Drainage Proposals Report
for a
New Science Block at the Xavarian College,
Manchester
undertaken on behalf of
Xavarian College

Report Title:	Drainage Proposals Report for a New Science Block at the Xavarian College, Manchester
Report Reference:	10961 – Xavarian College – Science Block – Drainage Proposals - Rev 01
Client:	Xavarian College
Issue Date:	November 2023
Drafted By:	Kevin Tyldesley
Authorised By:	Loughlin O’Gorman

- 1.1 WML Consulting have been commissioned by the Xavarian College to provide a Drainage Proposals Report for a proposed development at their site at Lower Park Road, Manchester, M14 5RB.
- 1.2 In particular the report has been composed to respond to the drainage related planning condition (number 11) contained in Manchester City Council's planning approval notice ref. 137030/FO/2023, a copy of which can be found at appendix 01.

Proposed drainage layout drawing

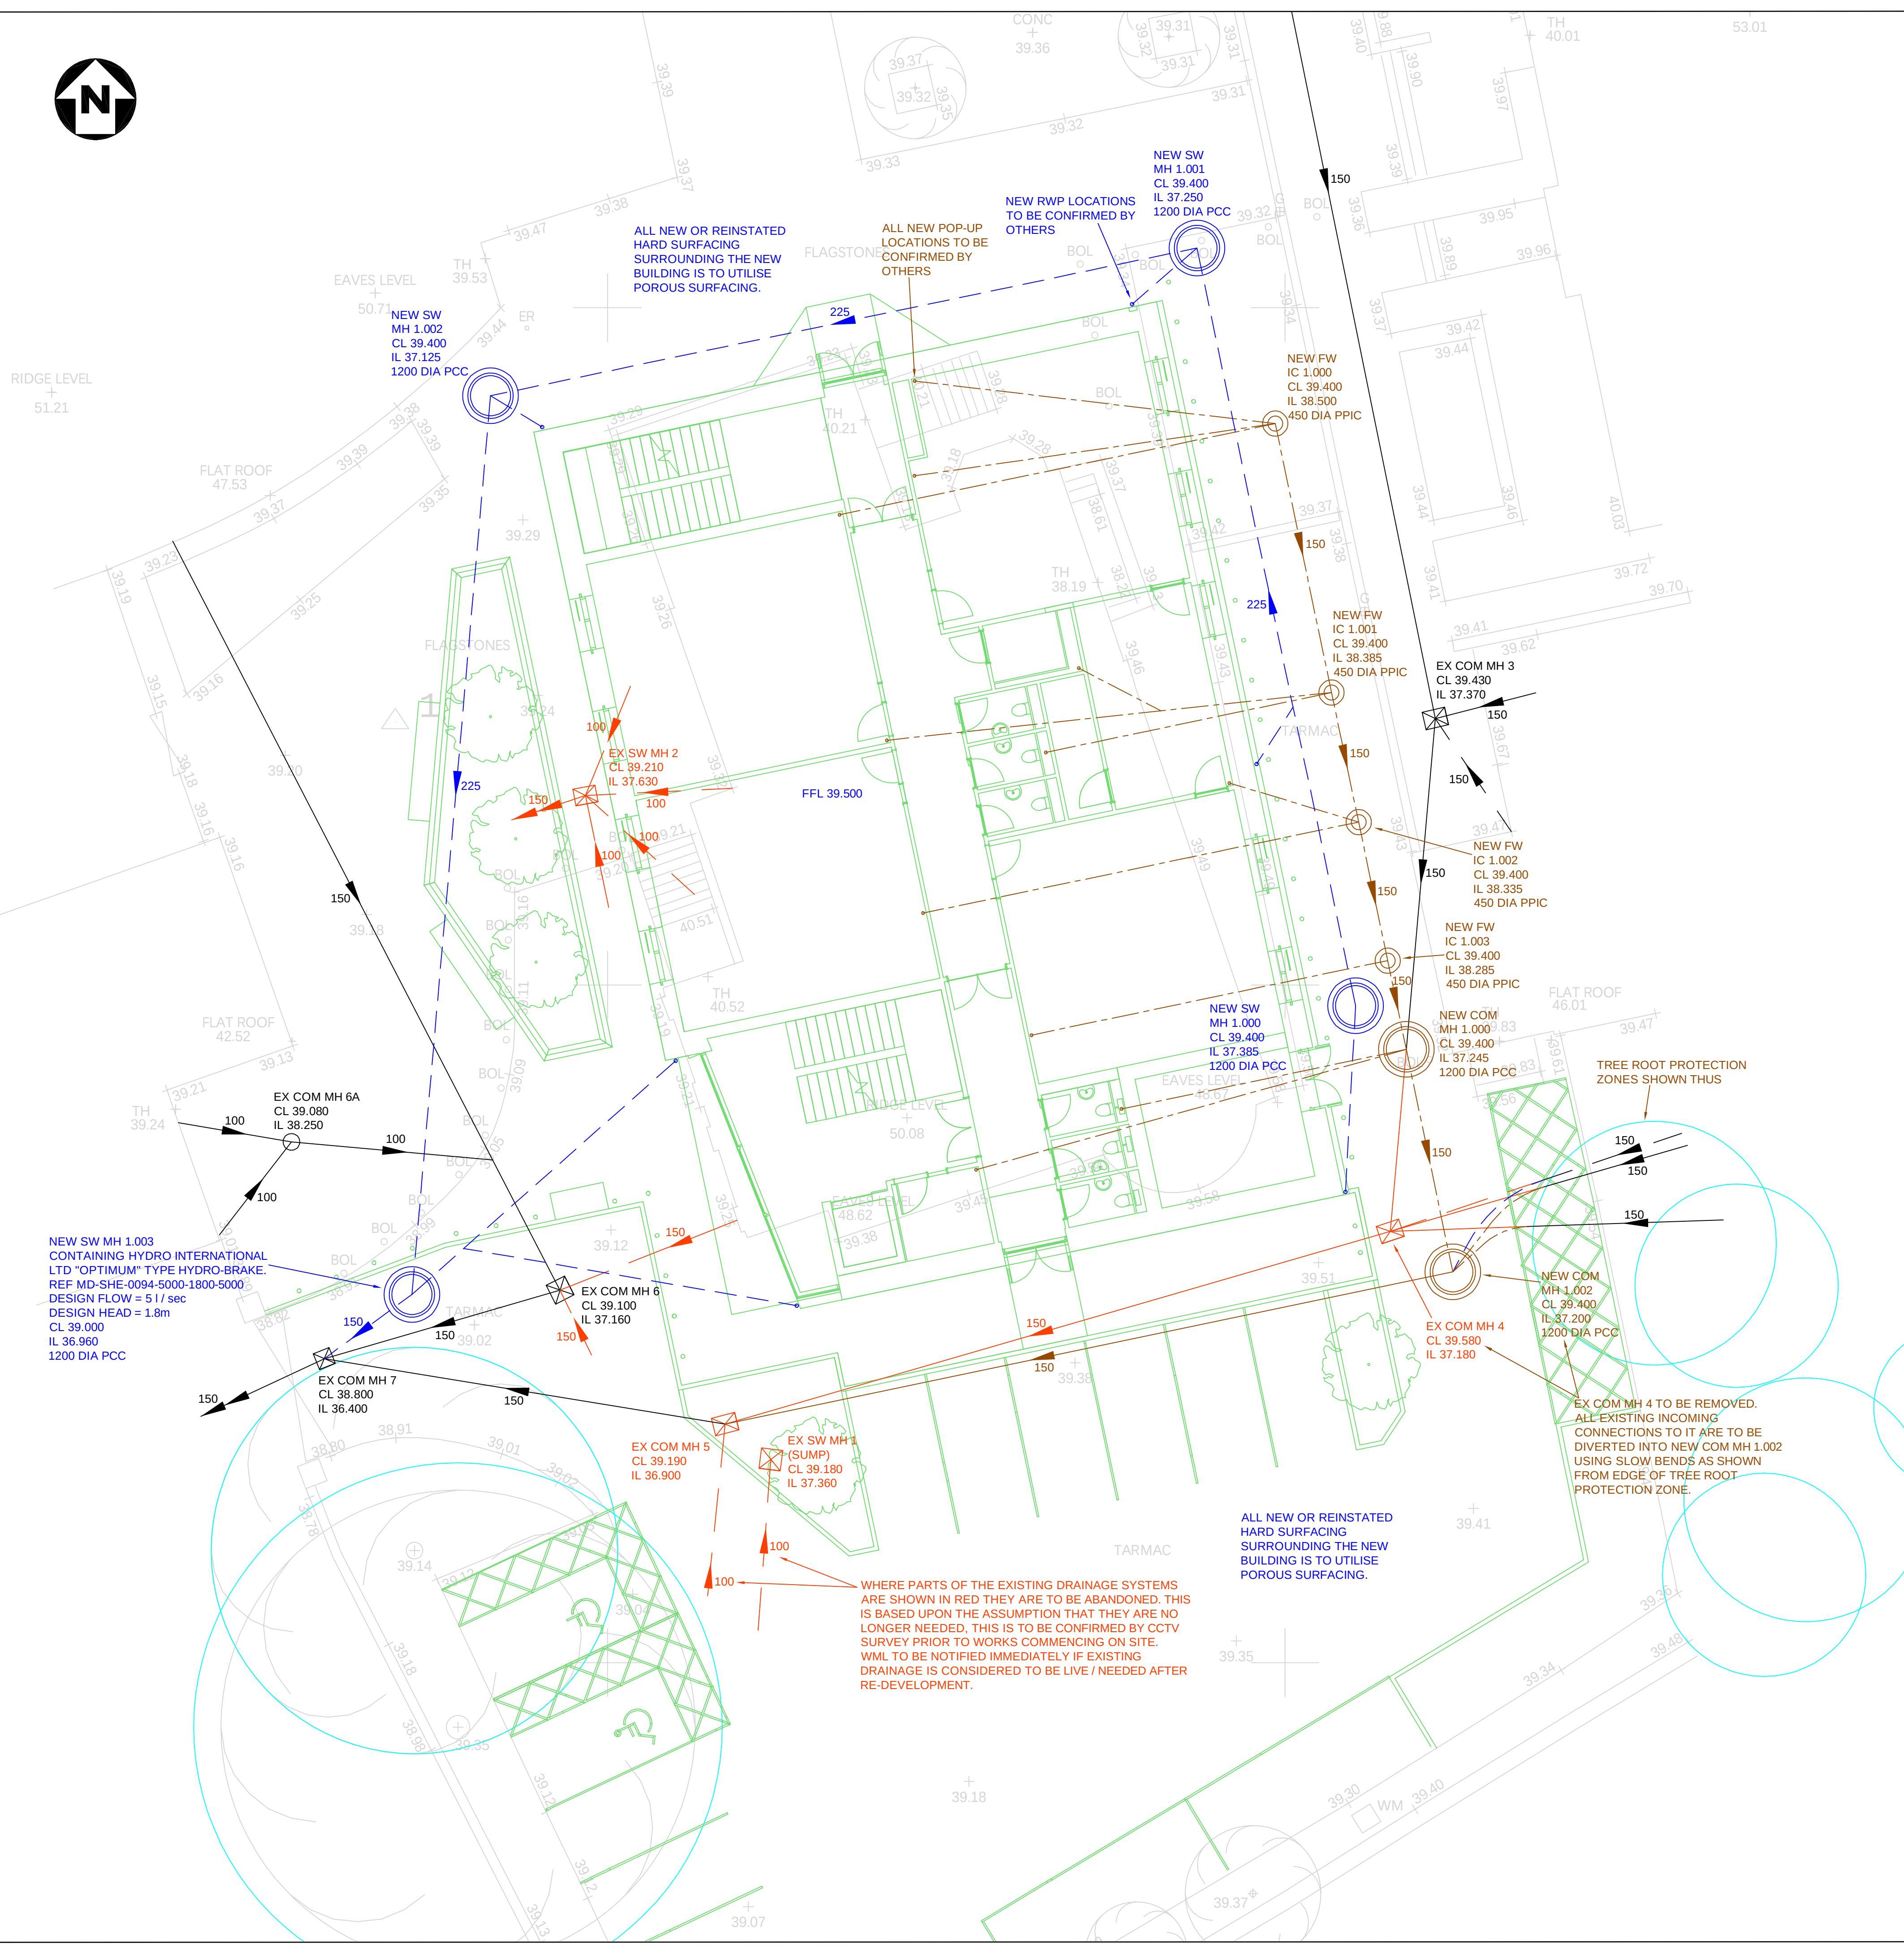
- A finalised drainage layout showing all components, outfalls, levels and connectivity; Refer to the proposed drainage layout drawing which can be found at appendix 03.
- Maximised integration of green SuDS components (utilising infiltration or attenuation) if practicable; Refer to the proposed drainage layout drawing which can be found at appendix 03, and the extract from the Phase 2 site investigation report at appendix 04, which confirms the ground conditions at the site are predominantly clay and are therefore not suited to the use of infiltration.

- Surface water should be restricted to a rate of 5 l/s.
Refer to the proposed drainage layout drawing which can be found at appendix 03.
- A blockage risk assessment is undertaken as part of the drainage strategy to support proposed flows less than 5 l/s. If the risk cannot be adequately managed, a higher minimum discharge rate should be considered / agreed with relevant.
Should the surface water drainage system become partially or fully blocked and thereby generate overland flows, any such flows would leave the site via the existing entrance to Thurloe Street, as this is the lowest part of the site. The proposed building's ground floor level will be around 0.7m above the existing levels at this site entrance. In addition the proposed building will not have a basement. Hence the proposed building will not be affected by a partial or full blockage of the proposed drainage system, and therefore the stipulated discharge rate of 5 l / sec is appropriate.

- Assessment of overland flow routes for extreme events. Overland flow routes need to be designed to convey the flood water in a safe manner in the event of a blockage or exceedance of the proposed drainage system capacity including inlet structures. A layout with overland flow routes needs to be presented with appreciation of these overland flow routes with regards to the properties on site and adjacent properties off site.
Should overland flows be generated as a result of a storm that is more onerous than the 1 in 100 year rainfall event with allowance for 45% climate change, or by a failure of the drainage systems, any such flows would leave the site via the existing entrance to Thurloe Street, as this is the lowest part of the site. The proposed building's ground floor level will be around 0.7m above the existing levels at this site entrance. In addition the proposed building will not have a basement. Therefore the proposed building will not be affected by the flows generated by an exceedance rainfall event or a blockage of the proposed drainage system.

- Progression through the drainage hierarchy shall be evidence based and supported by site investigation. Results of ground investigation carried out under Building Research Establishment Digest 365. Site investigations should be undertaken in locations and at proposed depths of the proposed infiltration devices. Proposal of the attenuation that is achieving half emptying time within 24 hours. If no ground investigations are possible or infiltration is not feasible on site, evidence of alternative surface water disposal routes (as follows) is required.

Refer to the proposed drainage layout drawing which can be found at appendix 03, which discusses the drainage hierarchy in the Drainage Strategy notation. Also refer to the extract from the Phase 2 site investigation report at appendix 04, which confirms the ground conditions at the site are predominantly clay and are therefore not suited to the use of infiltration.

Existing impermeable area plan

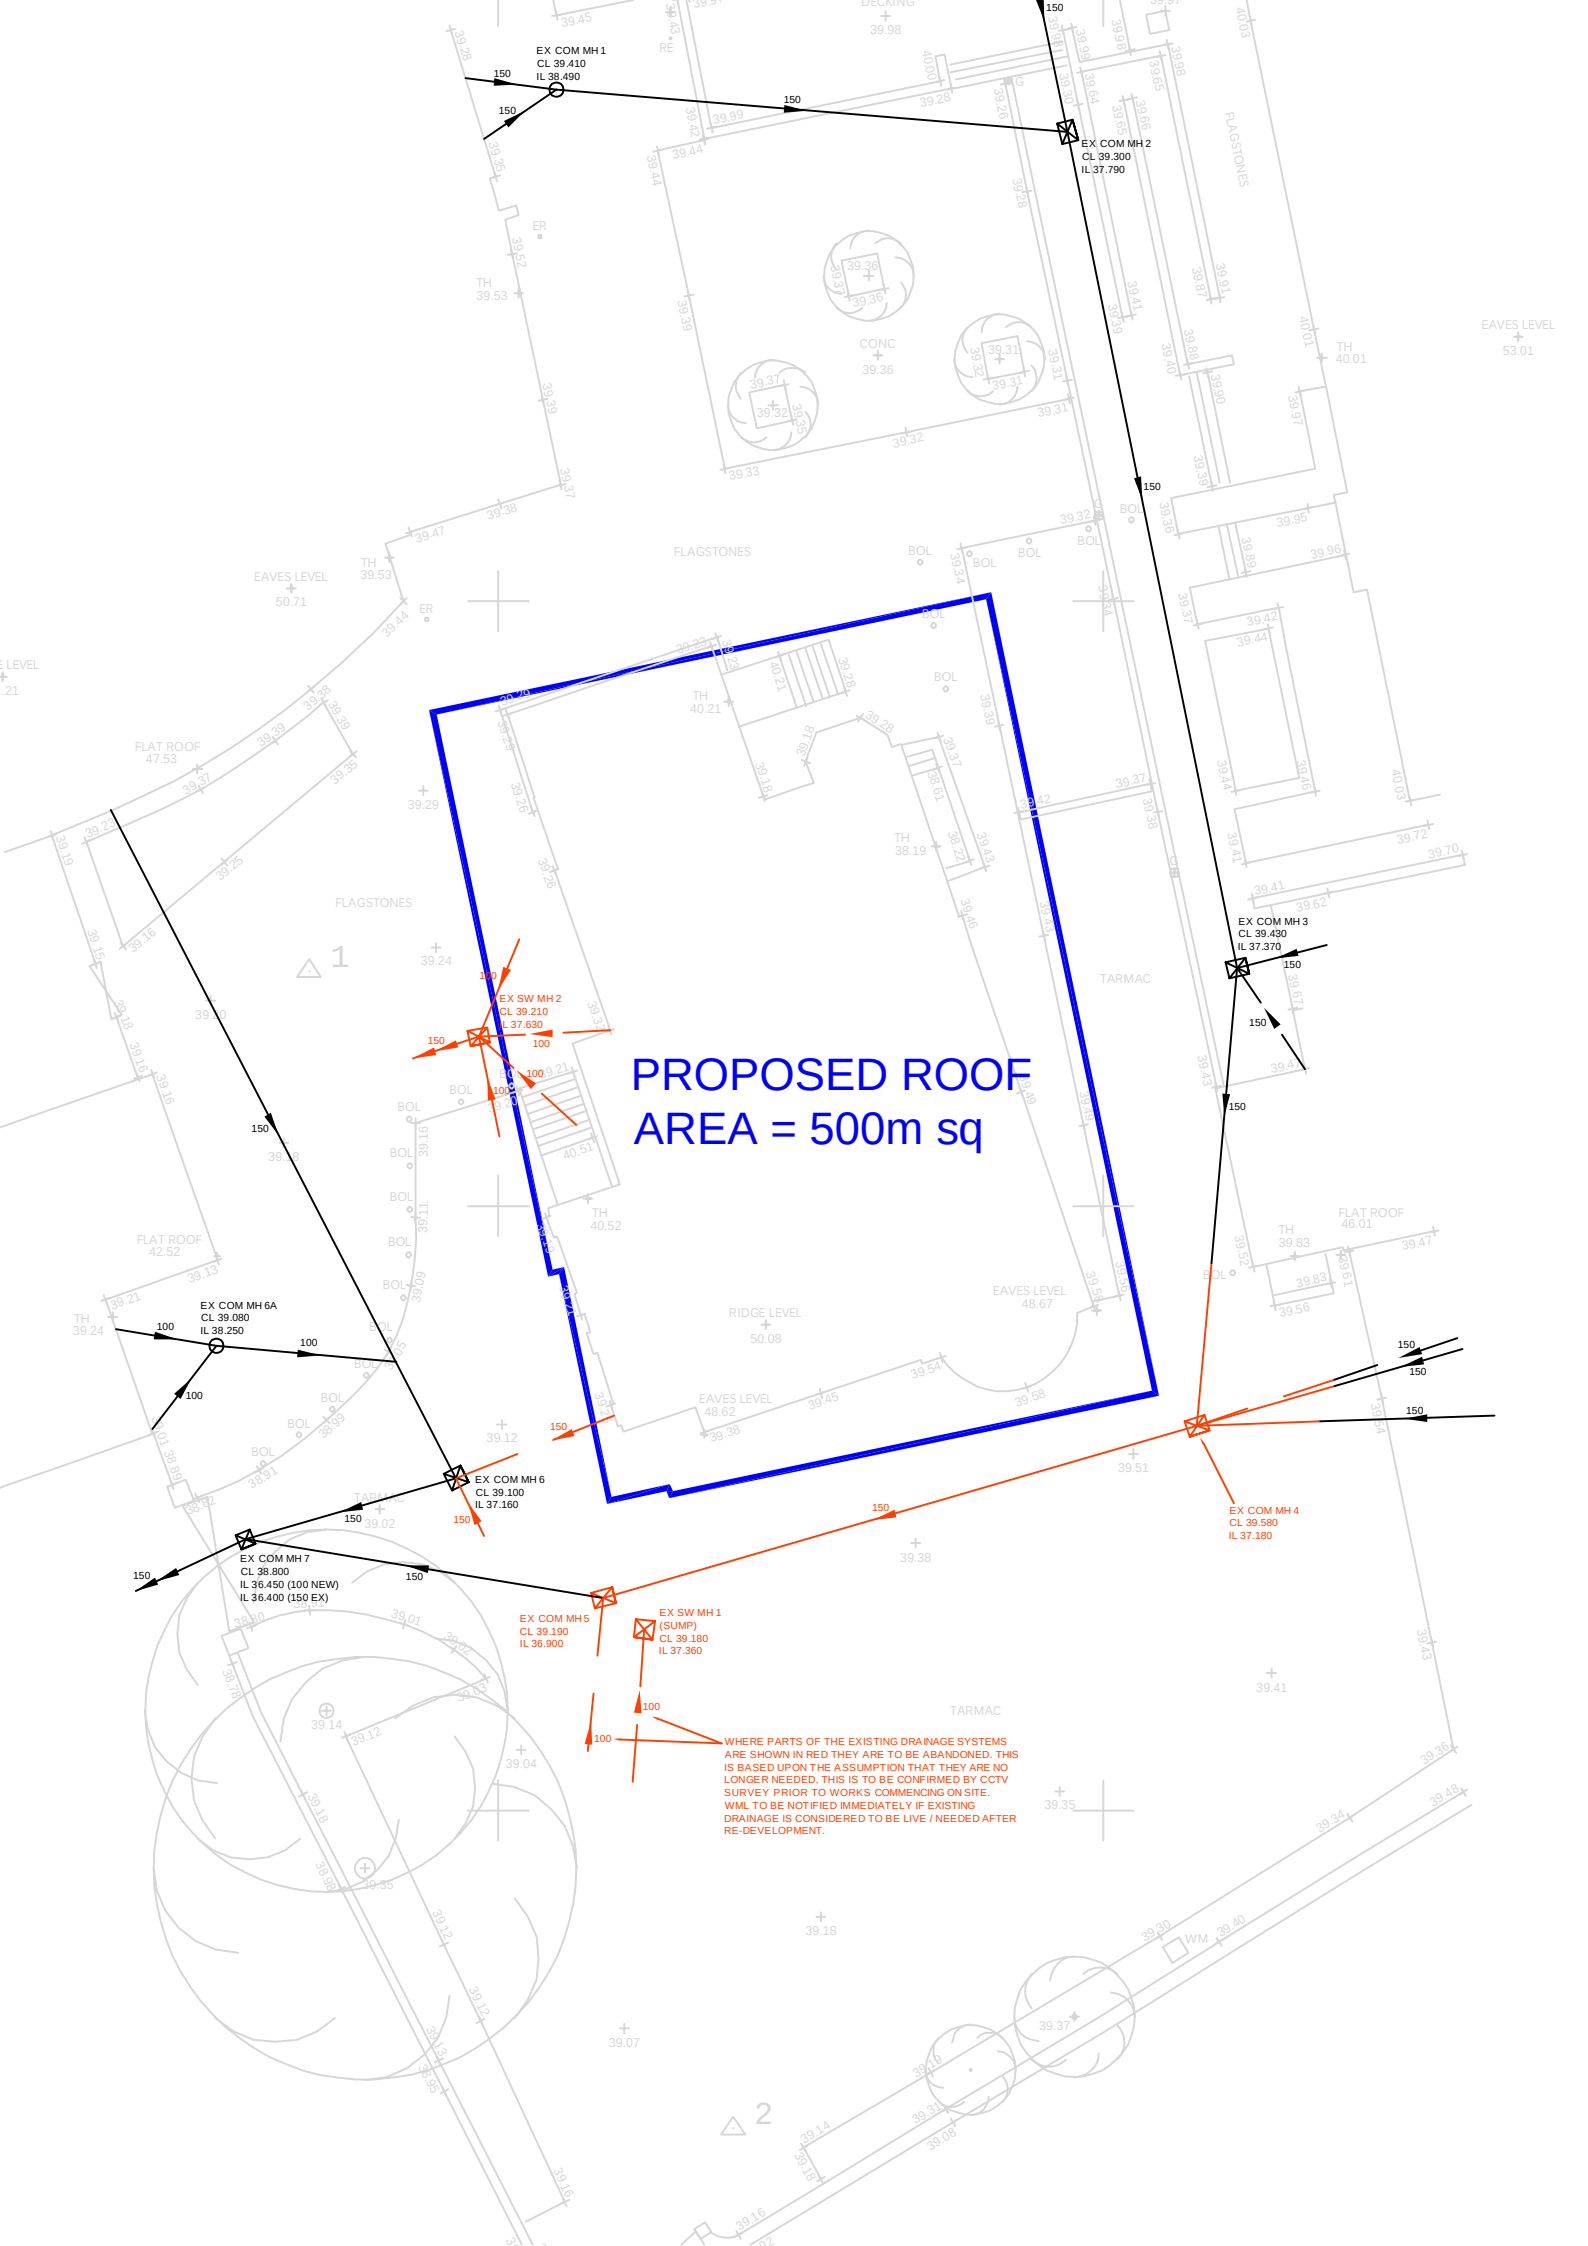
- An existing and proposed impermeable areas drawing to accompany all discharge rate calculations.
Refer to the existing impermeable area plan at appendix 05, upon which has been overlaid the outline of the proposed roof area of approx. 500m sq. As can be seen from this plan, the new roof area is proposed on an area that is currently all impermeable and positively drained. At appendix 06 can be found the proposed impermeable area plan.
